Access Compliance Report

Public Rights-of-Way

Intersection ID: 8852	Main Street: DOGWOOD_AV	Cross Street: GRIMES_ST	Location: W
ADA ID: 1F66A1A0BE62	Ramp Type: Perp	Initial Pass/Fail: Fail	Overall Compliance: No
Severity Score: 12.5			
Codes/Mitigation Info/Possible Solution		Field Measurements/Component Compliance

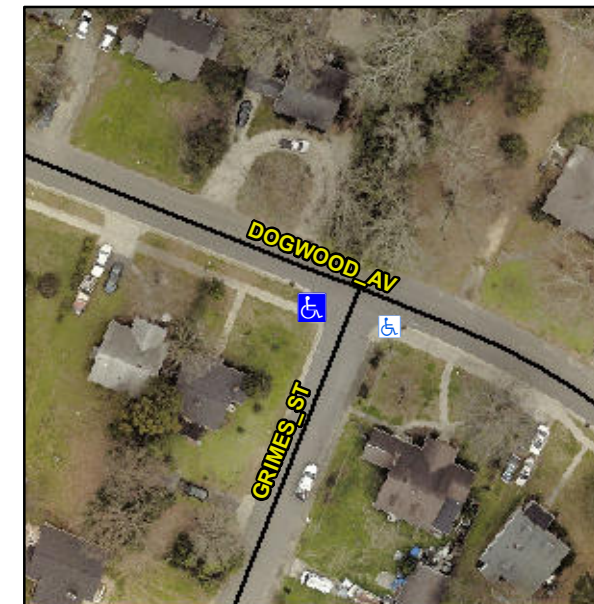
Not Found, R304.5.3

Compliance	Description	Data	Compliance	Description	Data
N/A	Ramp Length (in)	60.5	Yes	Ramp Slope (%)	8.2
Yes	Ramp Width (in)	48.0	No	Ramp XSlope (%)	5.2
N/A	Flare Type LT	N/A	N/A	Flare Type RT	N/A
N/A	Flare Slope LT (%)	N/A	N/A	Flare Slope RT (%)	N/A
N/A	Flare Traversable LT?	N/A	N/A	Flare Traversable RT?	N/A
N/A	Landing Length (in)	N/A	N/A	DWS Provided?	N/A
N/A	Landing Width (in)	N/A	N/A	DWS Contrast?	N/A
N/A	Landing Slope (%)	N/A	N/A	DWS Length (in)	N/A
N/A	Landing X Slope (%)	N/A	N/A	DWS Full Width?	N/A
N/A	Landing Curb? (Y/N)	N/A	N/A	DWS Offset (in)	N/A
N/A	Shared Landing?	N/A			
N/A	Gutter Ponding?	N/A	N/A	Gutter Slope (%)	N/A
N/A	Gutter Lip Ht (in)	N/A	N/A	Gutter X Slope (%)	N/A
N/A	Painted X Walk1?	No	N/A	Painted X Walk2?	N/A
	X Walk 1 Direction	To SE		X Walk 2 Direction	N/A
N/A	X Walk 1 Width (in)	N/A	N/A	X Walk 2 Width (in)	N/A
	X Walk 1 Slope (%)	1.6		X Walk 2 Slope (%)	N/A
	X Walk 1 X Slope (%)	3.8		X Walk 2 X Slope (%)	N/A

Remove & Replace Entire Ramp.
